Agenda Item 3 1965 Windridge Building Scale Variance for a Pergola

Staff Report

Agenda Item 5 821 Northmoor Road **Revisions to Previously Approved Plans Building Scale Variance and Height Variance**

Consideration of a request for a square footage and height variance for an inprogress addition to an existing home including a garage addition, expansion of the entryway on the first floor, and expansion of the second floor of a singlefamily residence. Various exterior alterations to the residence and modifications to the site plan are also proposed.

CONCEPTUAL RENDERING

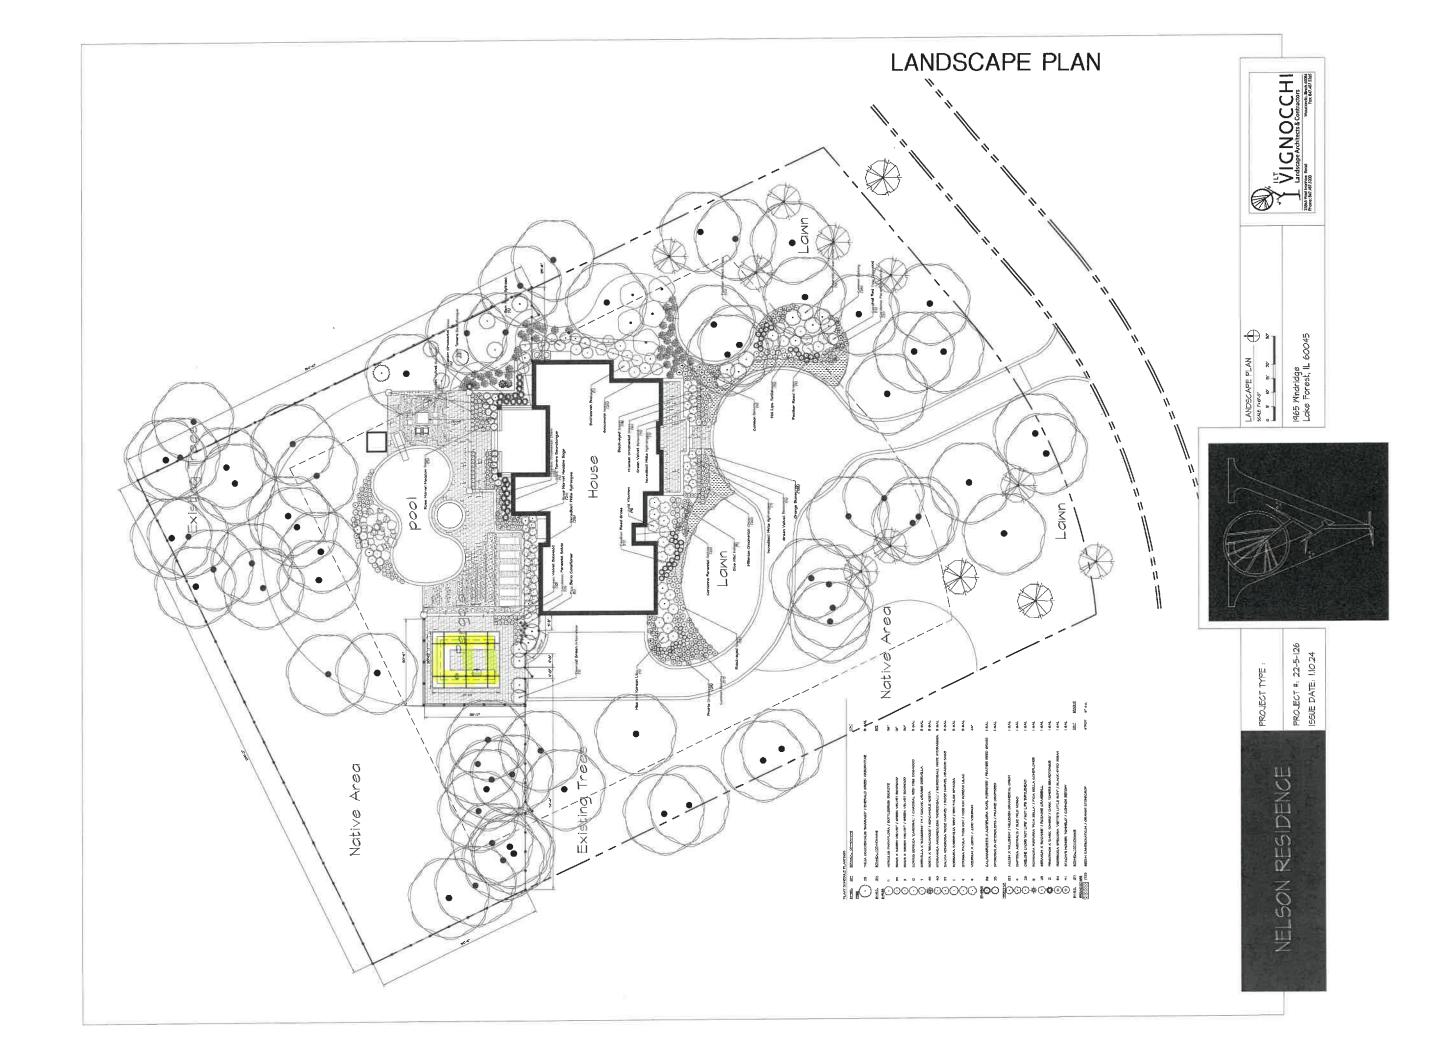
This standard is met. The proposed pergola, placed in the rear yard behind the house and landscape screening, is sited so that it does not impact the appearance of mass from the streetscape. There is no lighting in the pergola based on the plans submitted.

EAST BUILDING HEIGHT ELEVATION SCALE: 1/4"=1'-0" DATE: 5/3/24

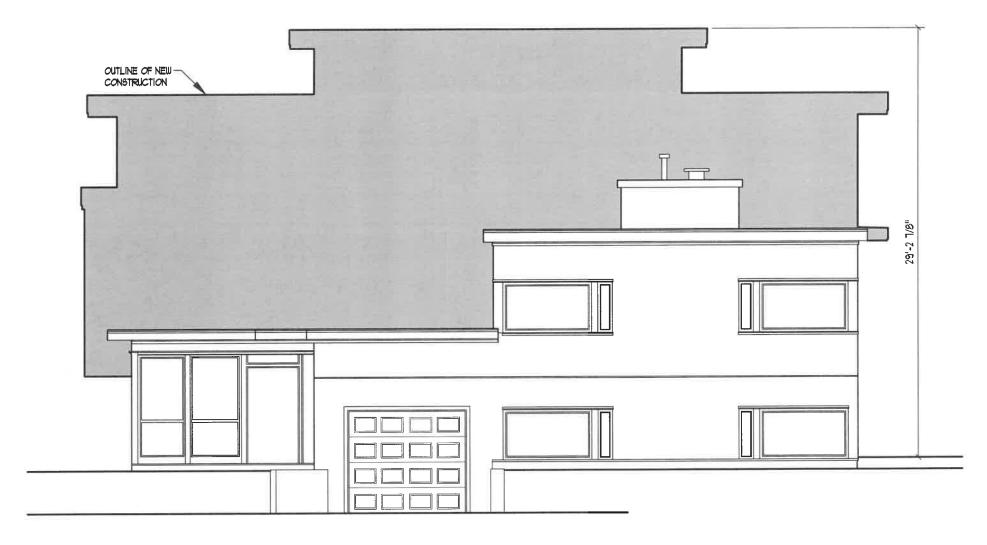
According to the petitioner's original design drawings, the proposed residence was to be 25'-7" in overall height as measured from the north elevation at the driveway to the top of the stairwell lantern lightwell. Due to design decisions made during construction, the overall height of the house is approximately 34' as measured from the north elevation driveway which is the lowest adjacent grade to the top of the stairwell lantern lightwell. The following construction modifications contribute to the height change:

- An additional 2' of ceiling height was added to the kitchen level.
- The existing garage finished floor was lowered by almost 2' to align the existing second floor with the second-floor addition.
- The lantern lightwell is almost eight feet taller than initially proposed. In the
 original plan an existing chimney was constraining the lantern height but
 the chimney was removed as explained to staff, due to its deteriorated
 condition.
- The roof height of the second floor was also increased when the roofing material was changed, and a parapet wall was added to hide the slope now necessary for the material change.

Recommendation: Provide a plan showing how the house can be modified to reduce the overall height to 30' and the square footage to the allowable total of 2,875 square feet.

NORTH ELEVATION OVERLAY JULY 18TH, 2024

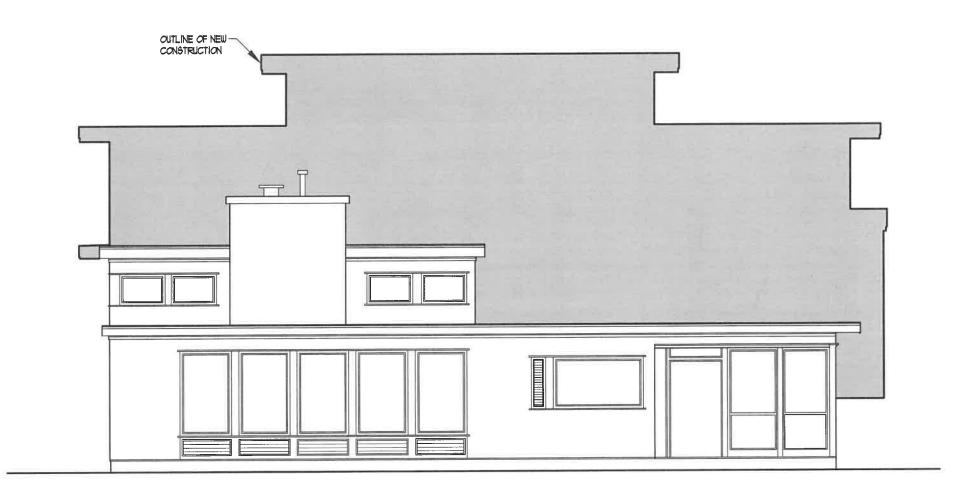
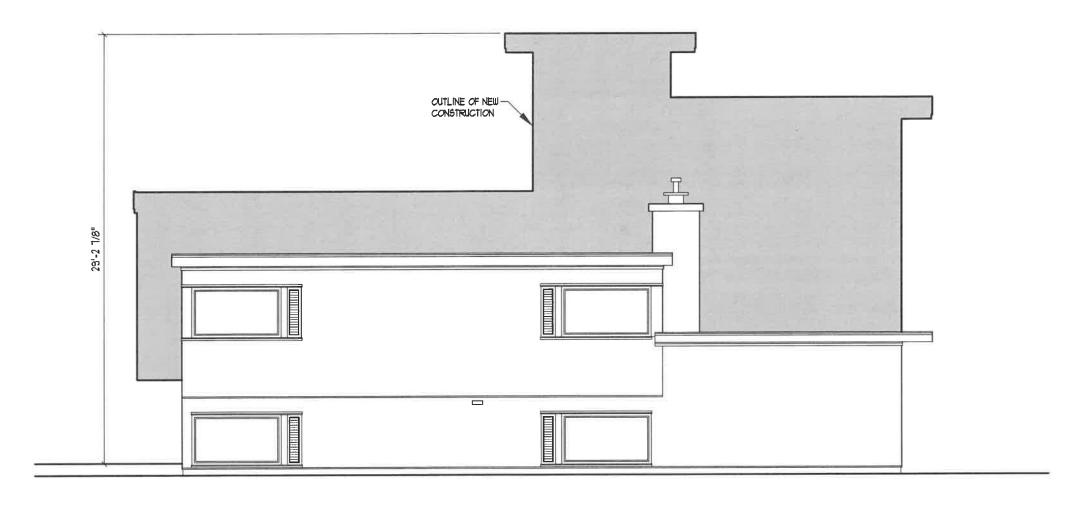
- West Elevation A window was added at the stairwell lantern lightwell.
 The second story master bedroom windows were changed from 35"x71" to 32"x60". The windows on the first and second story were also changed in size and configuration from the approved plans.

- South Elevation Three windows were added to the stairwell lantern lightwell after permitting, and the sliding glass doors on the first floor and the windows above them were reduced in size from the approved plans. The large window in the master bath was also reduced in size and the three first floor windows in the kitchen were adjusted in size. The modifications made to the first and second floors improve the mass and void of this elevation.

Recommendation: The modified window sizes work with the taller elevations but could result in off site light impacts to neighboring homes. The added windows at the stairwell lantern lightwell should be removed and that element lowered in order to meet the allowable building height of 30'.

LANDSCAPE PLAN JULY 18TH, 2024

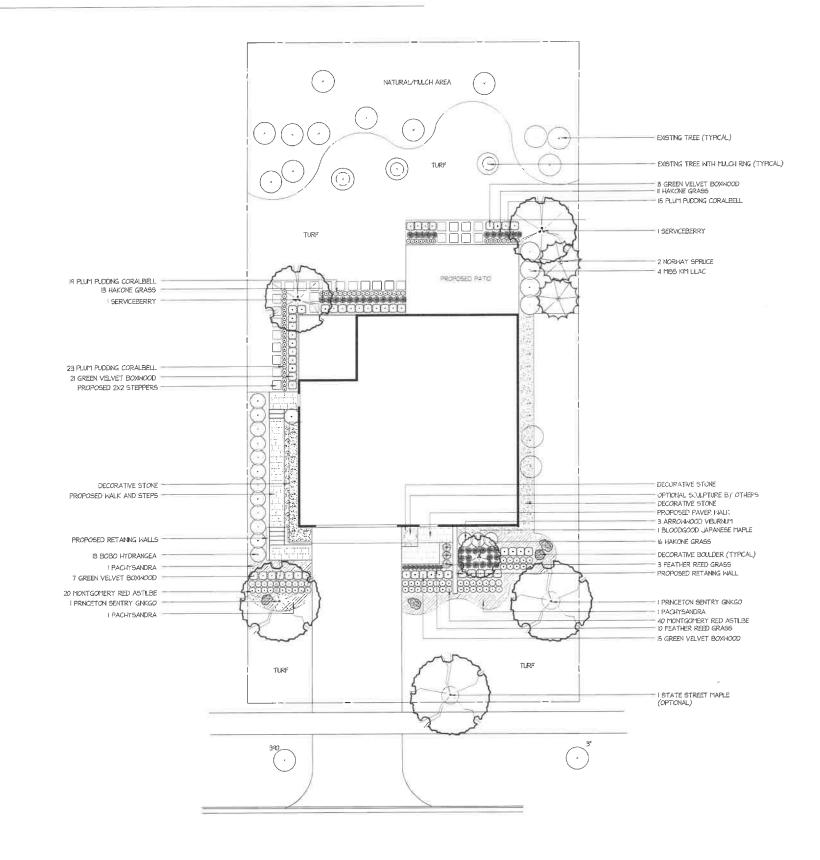
In review of the recently submitted landscape plan it appears that four additional trees were removed from the site, beyond those originally identified for removal including trees 761, 775, 776, & 792. Clarification is needed as to the current status of these trees. If the trees have been removed or are intended to be removed a separate tree removal permit and any required replacement inches need to be calculated for the removals.

PROPOSED LANDSCAPE PLAN JULY 18TH MEETING

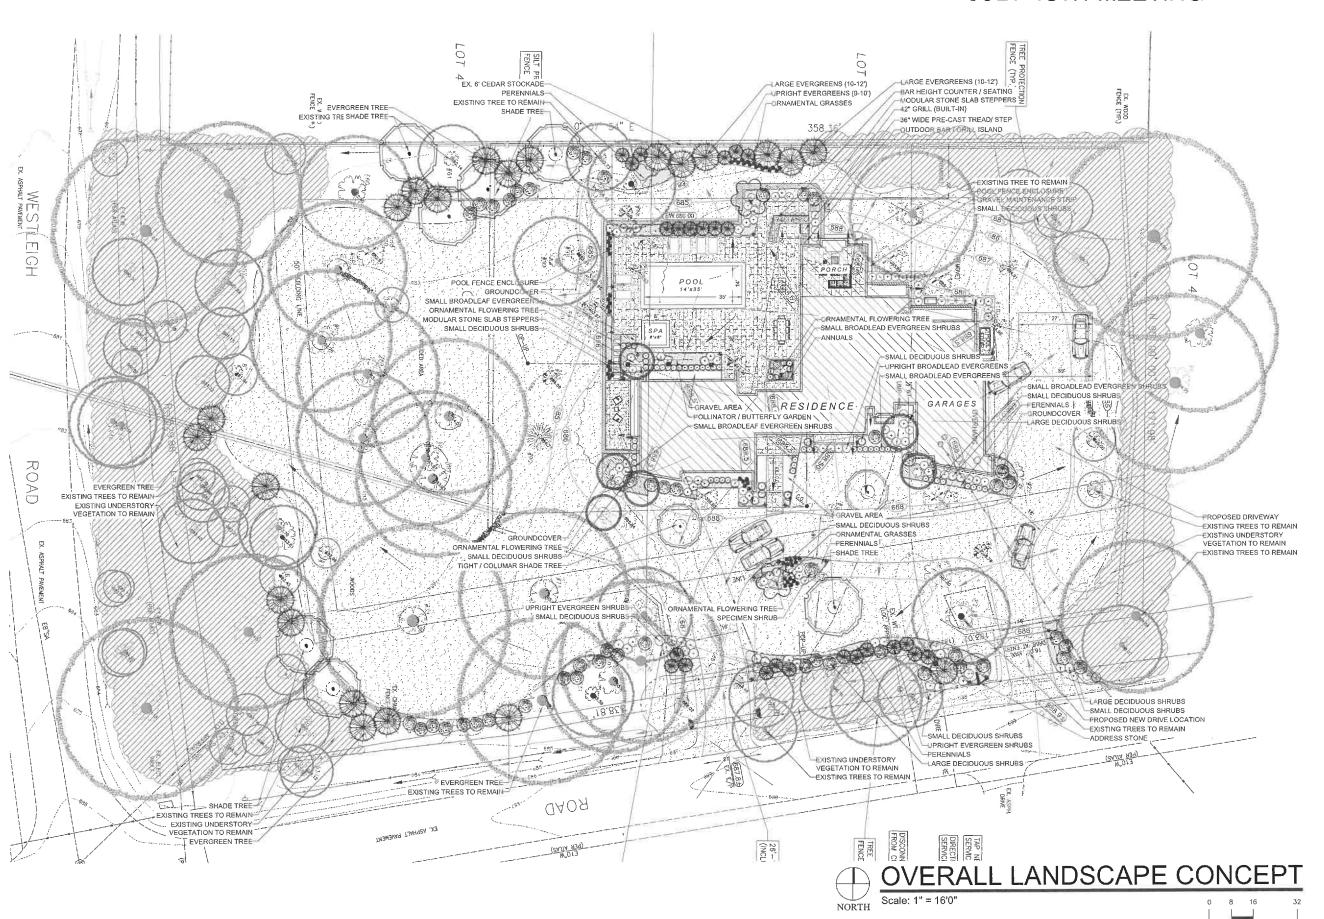
An updated landscape plan has been submitted adding additional buffer plantings along the west property line and includes a planting bed along the west and south sides of the pool deck. The buffer plantings include Green Giant Arborvitae, Norway Spruce, and Black Hills Spruce trees in addition to several bushes and perennials. The plans still show the preservation of the extensive buckthorn hedge that runs along all sides of the lot in patches. The planting schedule shows seven new deciduous trees being proposed at 2.5" size for a

total of 17.5". These trees do not replace the removal inches but will count against the replacement cost.
